ROHDE & SCHWARZ

Release Notes

Firmware V4.30

R&S[®] PR100

4.6 Saving of waterfall buffer

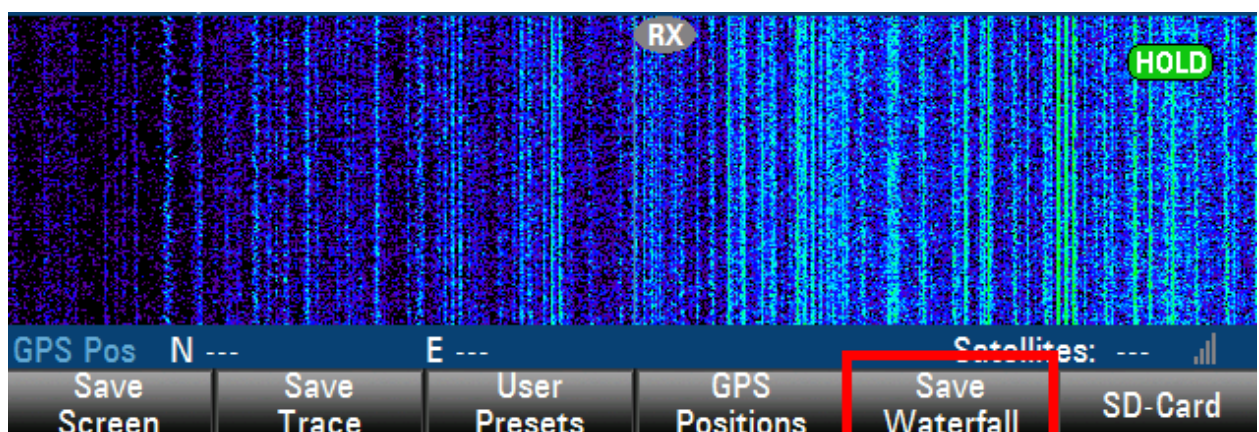
The waterfall buffer can now be saved to the SD-card. This function can be activated under “FILE->Save Waterfall”. The waterfall buffer will be saved in the “.rtr” file format which can be replayed on the instrument.
